# Rampion 2 Wind Farm

## Applicant's Comments on Deadline 3 Submissions

**Date: June 2024**  
**Revision A**

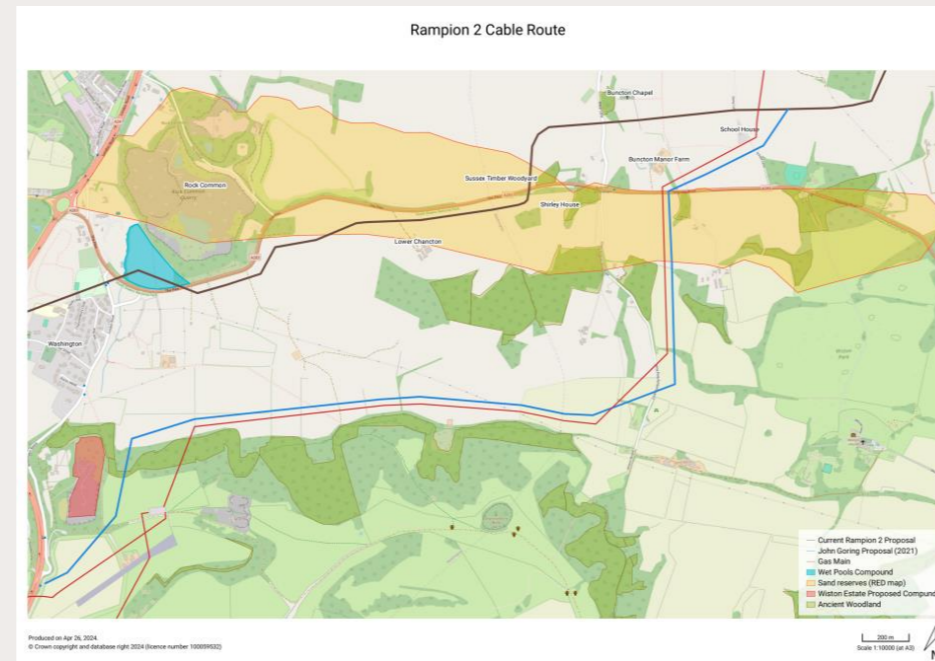
This plan also shows the approximate location of the gas pipeline, referred to by the Applicant under 2.28.47. We understand it is acceptable to lay a cable within 15m of a gas pipeline. For this alternative, the proposed route is at least 30m away from the gas pipeline and therefore should be acceptable. It would not involve “multiple crossings of a shallow gas pipeline which is less desirable” as stated by the Applicant under 2.28.47.

Given the easement of the in-situ gas line, the Applicant could have significantly minimised the sterilisation of the sand within WSCC MSA (shown in yellow on the attached plan) by running the cable route parallel across the sand seam. As stated, we do not believe this alternative has been given sufficient consideration by the Applicant.

The Applicant responds to the points raised in relation to the blue route including the clarification on interaction with ancient woodland under section 2.28.12.

The Applicant set out the Engineering challenges in relation to the topography and gas pipeline in our response at Deadline 3 in **Applicant's Responses to Affected Parties' Written Representations [REP2-028]** and included. Further details of these risks are also set out in the **Applicant's Responses to Action Points Arising from ISH2 and CAH1 (Document Reference 8.70)** Action point 10.

Figure 1: Mr Dickson proposed Cable route at Kent Street 18/4/24

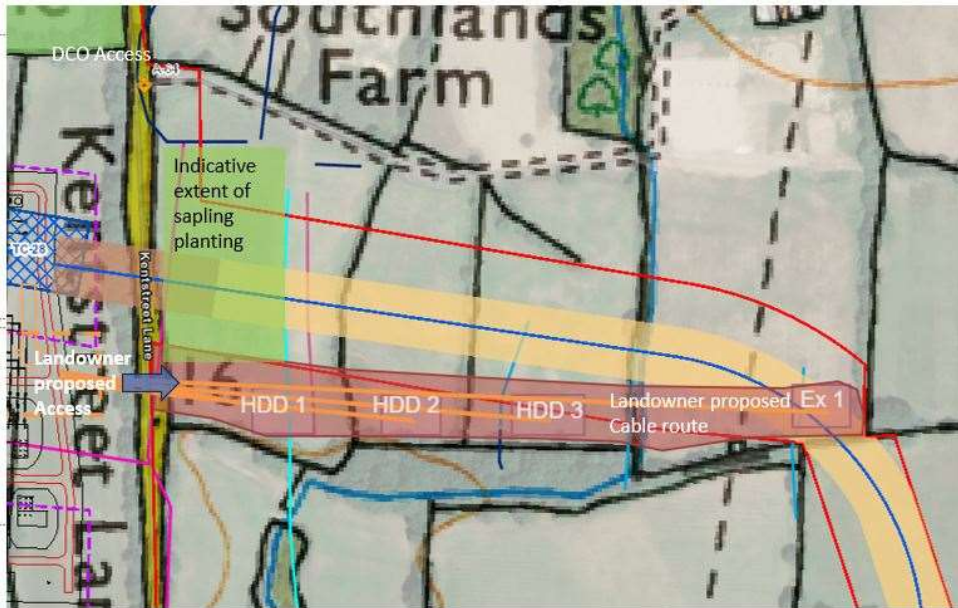
We looked on site at your proposed cable route as shown on the plan sent by email from Simon Mole on 18<sup>th</sup> April. We have transposed this onto the Rampion 2 Works plan base and this is included below for ease of reference. The cable route proposed by you is identified in shaded red and labelled 'Ex1' on the plan. It was noted on site that your proposed cable route is of varying width and partially within and to the south of the DCO red line boundary shown by the red lines. We also discussed trenchless crossing exit locations in the different fields east of Kent Street.

The current DCO route shown by the red lines (and an indicative cable centreline by a blue line) at Figure 1) exits eastwards from the proposed Oakendene substation and crosses Kent Street by trenchless crossing method. Your suggested route would require the cable route to exit from further south in the Oakendene substation site. Our lead engineer, Toby Lee, who was at the site visit has discussed this with his engineering team. The ongoing design work on the substation layout indicates that movement of the trenchless crossing entry point south within the Oakendene site cannot be accommodated due to the requirements of the substation site infrastructure.

Fig 1a

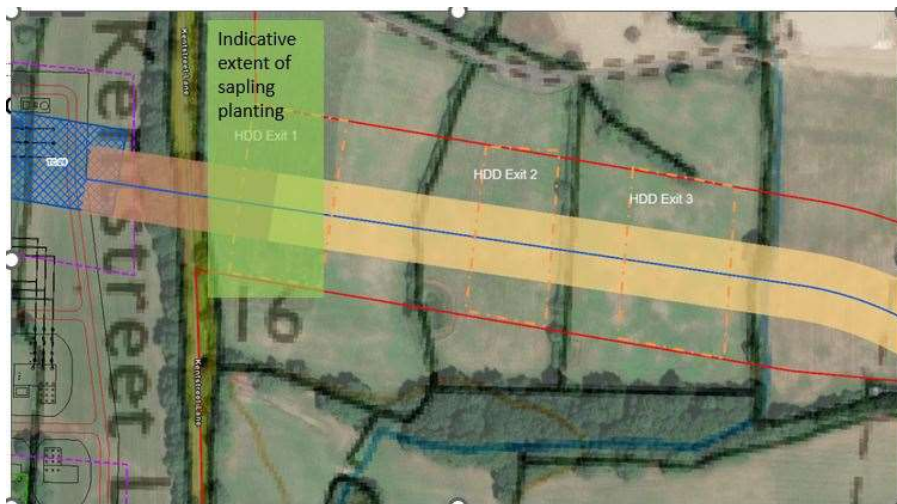
These are the main points we wish to see incorporated into the Key Terms with reference to a corresponding (updated) plan based on Fig 1a in your letter. If these points can be agreed and a binding agreement (by way of a legal undertaking) can be reached our client will withdraw his representations in respect of the land at Kent Street.

The Rampion 2 team has considered how it would be feasible to address some of your concerns by avoiding existing sapling planting. For example, by retaining the cable corridor within the current DCO boundary but extending the trenchless crossing exit to the second field east of Kent Street (HDD 2). The requirements for access from Kent Street to the location of the trenchless crossing exit and onwards along the cable route would still need to be discussed and agreed as it is likely this would still be required from the existing access off Kent Street, which I note is not currently in vehicular use due to it being blocked by the storage container. Furthermore, appropriate offsetting from the pond would be required. I would be grateful if you could let me know if you would be prepared to continue discussions on this basis (via Simon Mole if appropriate). Please note that the extended trenchless crossings beyond the second field (HDD3) were deemed to be of unacceptable additional cost due to the significantly extended length of trenchless crossing which are not justified. It is noted that in any event the saplings would be avoided by exiting in the second field.

Figure 3 – Mr Dickson's proposed “Alternative route 3” with Rampion 2's identified tree line constraint.

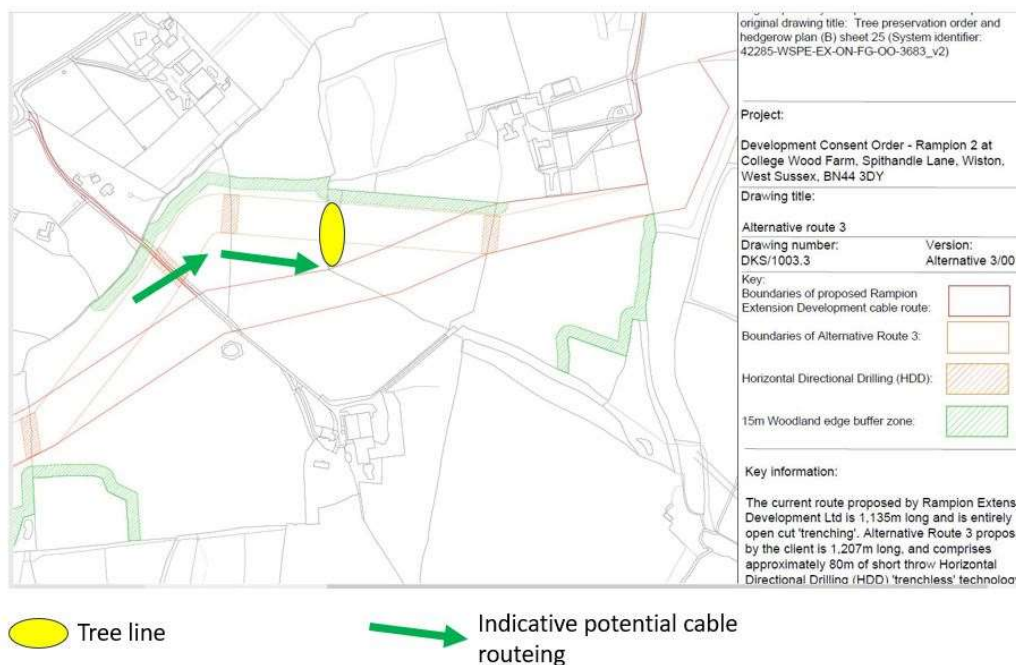
Rampion 2 has assessed the proposal which you have put forward as “Alternative Route 3” shown on your plan (DKS/1003.3 at Figure 2 below) as submitted in your relevant representation. We understand that this is now your preferred alternative of the 3 options presented in your relevant representation, but please confirm.

We cannot progress Alternative Route 3 because it would require crossing the tree line (as shown by the yellow circle we have marked on your plan at Figure 3 below). We also note the 5 trenchless crossings of features proposed in Alternative Route 3 which, as explained in our responses to your relevant representations, are not considered to merit trenchless crossings.

Figure 3 shows an indicative cable routing solution (the green arrows) which is potentially acceptable to Rampion 2 and this option proposes the cable route in a location as far north as practicable, taking into account the known constraints. It maximises the extent of land to the south of the cable corridor whilst being acceptable in engineering and environmental terms.
